Technical Bulletin

Model
911 Carrera

Subject: Rear Heater Fan Modified

Number
9202

Figure 1 (new version shown)

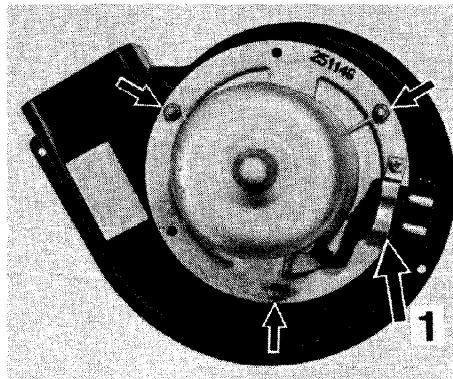
Repair Information: The replacement rear heater fan (new Part Number 965 624 151 00) has a repositioned wiring plug. When installing this new version heater fan in the 911 Carrera, model years 1984 (E) through 1989 (K), the fan motor must be repositioned in the fan housing.

Work Procedure: Remove the three fan motor mounting nuts (arrows in Figure 1). Reposition the motor 120° clockwise in the housing. Reinstall nuts and torque to 2.5 Nm (1.85 ft. lbs.).
